From: Jim Birch <jbirch@mbari.org> 
Subject: MBARI's way forward....
Date: December 20, 2013 4:17:48 PM PST
To: Bryant Grigsby <bgrigsby@accelbiotech.com>, David Boone <dboone@accelbiotech.com>
Cc: Doug Pargett <pargett@mbari.org>, scott jensen <sjensen@mbari.org>, Roman Marin III <maro@mbari.org>, Brent Roman <brent@mbari.org>, Bill Ussler <methane@mbari.org>, Chris Preston <preston@mbari.org>, Scholin Chris <scholin@mbari.org>, Jim Birch <jbirch@mbari.org>

2. Direction for lyse-n-go development

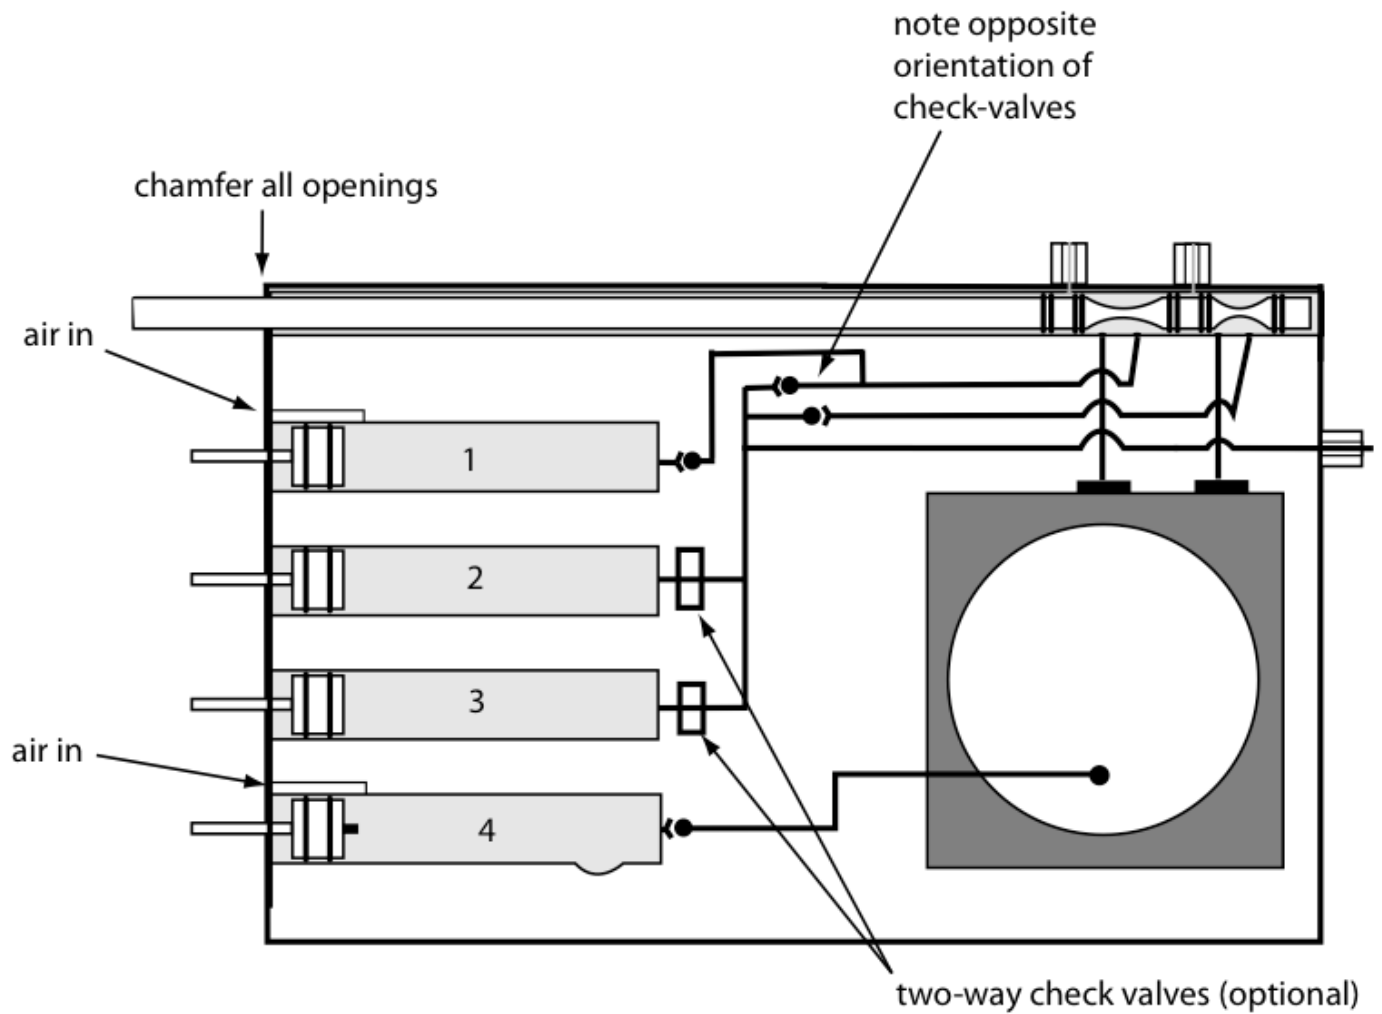
We think we may have a simpler solution that does away with a three-position valve near the off-cartridge port (see attached figure).

- syringe 4 is your new design that allows pressure bleed-off.
- syringe 1 still has the air-refill groove and needs a check valve oriented the same way as the check valve at syringe 4 (but no plunger boss).
- Reservoirs 2 & 3 have the option for two-way check valves (so that stored material will be closed to the environment.)
- Big modifications are in the plumbing
- chamfer all reservoir ends so we don't damage o-rings when inserting plungers. Same on cartridge plunge valve.
- The prototype version of this should allow us to mount a stop-cock valve at/in the exit port [1/4-28 female threads in body of cartridge].

This arrangement allows us to test all three types of puck clearing: liquid displacement, air evacuation and diaphragm evacuation. Please think about this schematic, and then we'd like to have another meeting with you before cutting any prototype 'metal'; could we do this ASAP once the holidays are over?
